**Service information**

**Reference no.:** SDA\_108020

Appliance does not heat due to blown boiler TRIAC ST

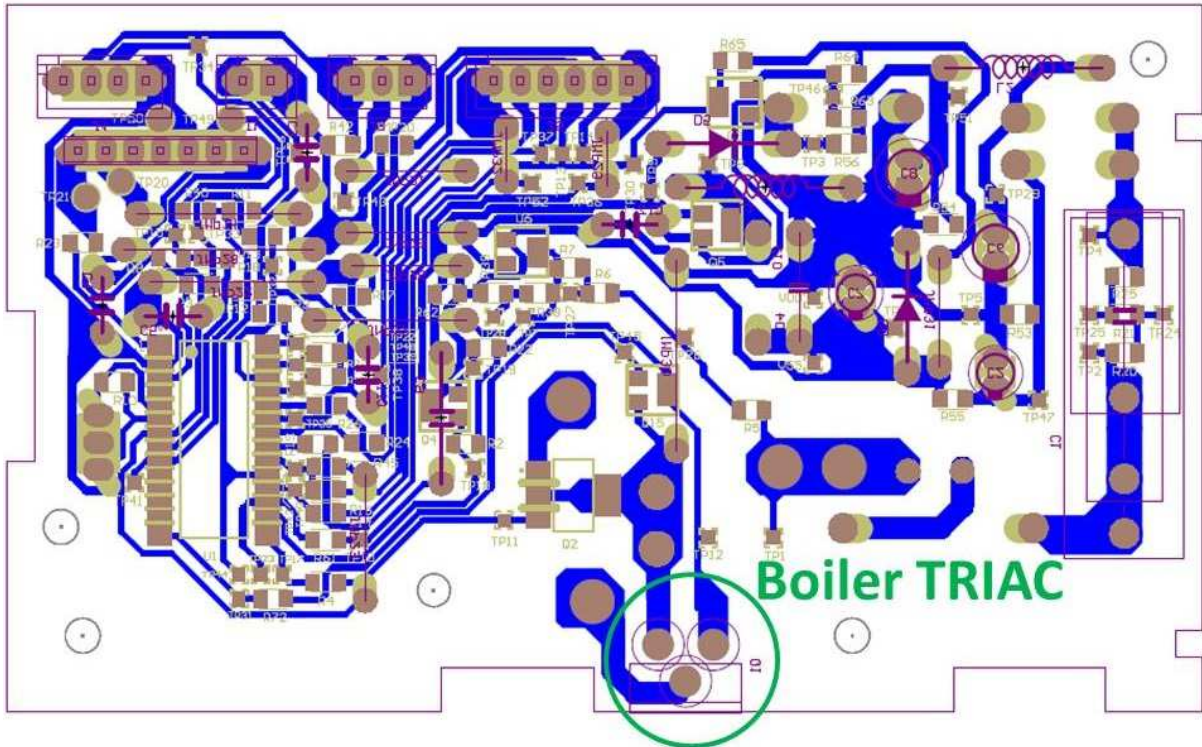
The cause for the Boiler TRIAC to blow, is likely to be an earth leakage of the boiler, therefore the boiler must be preventively replaced. Please refer to attached image for an overview of the back (solder side) of the PCBA, and the area to inspect.

Apart from the PCBA

- 42225951853

also replace the Boiler

- 42225952091
